NOTICE OF DECISION

FILE: SP-10-18 (Modification to file SP-02-17 / SP-03-17)

TYPE OF APPLICATION: Request to modify a condition of approval to remove an existing maple tree and replace it with a new Maple Tree and two Alaska Cedars.

**HICKORY HOLLOW
 APARTMENT
 COMPLEX**

L1.1

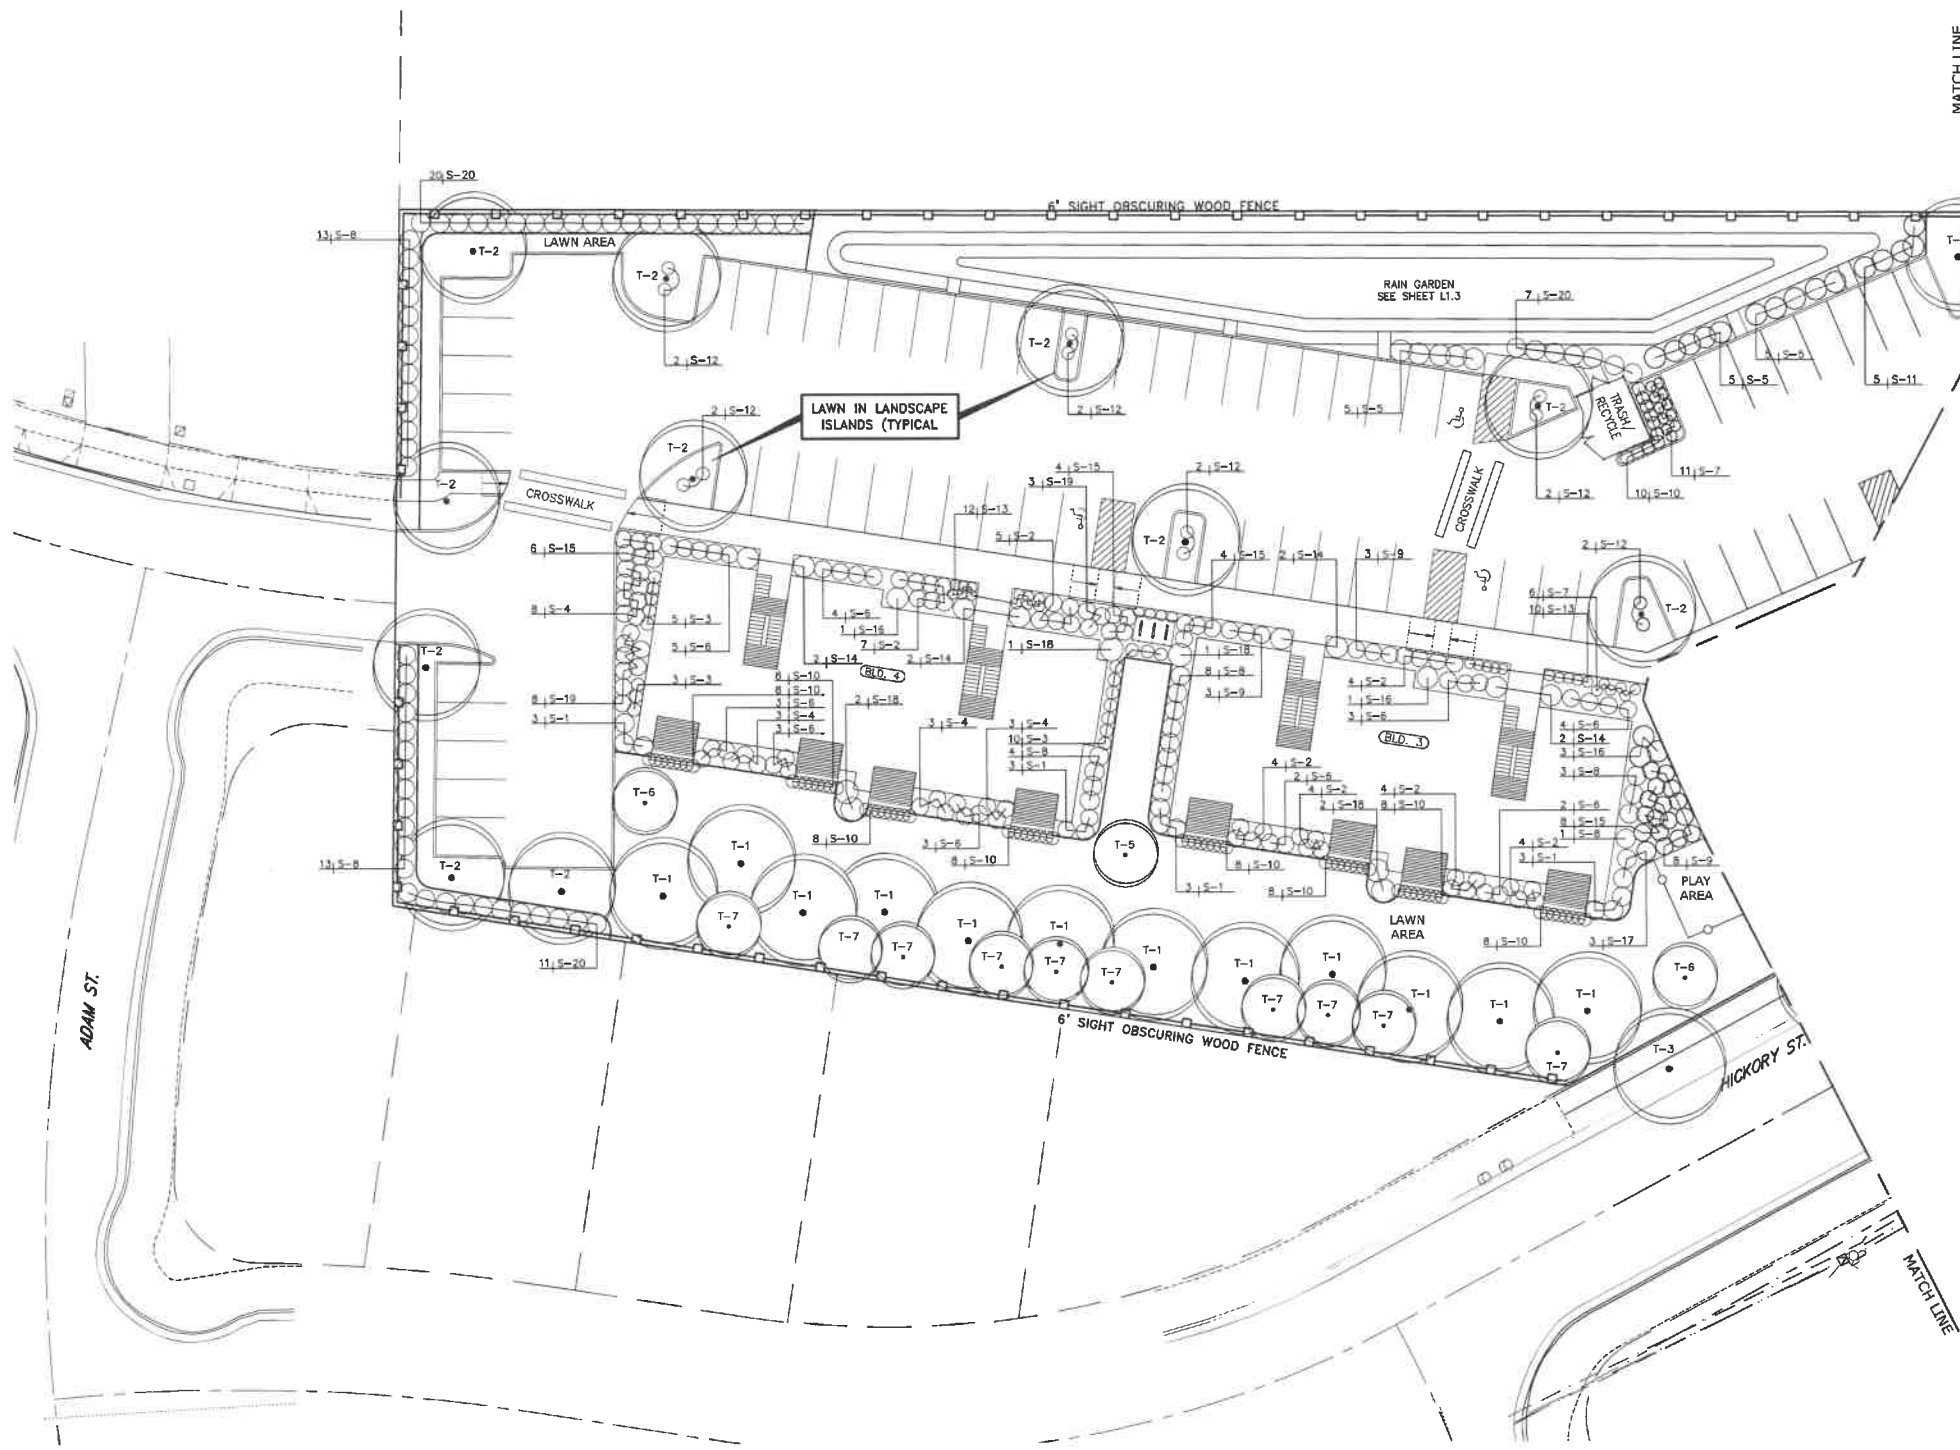
9. **Tree Preservation** – The existing Maple tree may be removed if it is replaced with one *Bowhall Red Maple*, and two *Green Arrow Alaska Cedars*, or similar species, as presented in the attachments, Sheet L1.1 and Sheet L1.4.
